Technical Memorandum

Date: January 3, 2013

Subject: Phase II Environmental Site Assessment Results and
Recommendations, Blue Heron Mill, Oregon City,
Oregon

Figure 1
Proposed Sample Locations
Phase II ESA
Blue Heron Site
Oregon City, Oregon

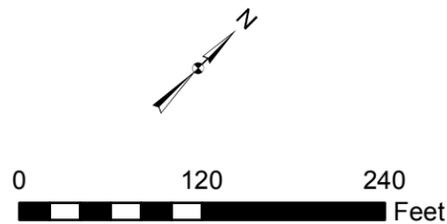
6. Based on the proposed sample locations in Figure 1, it does not appear that an investigation or survey is planned for the northern waterfront area north of pump station #2 up to the northernmost property boundary during this phase of work. It is not clear if this area was assessed in the Phase 1 ESA. This area appears to be well vegetated, has a natural shoreline and at least three historic outfalls. DEQ suggests that Metro/ERM consider some sort of assessment or survey of the area during this phase of work that focuses on current conditions, apparent runoff patterns, evidence of historic industrial use and any obvious environmental issues in the area. This information may prove useful to Metro in future considerations.
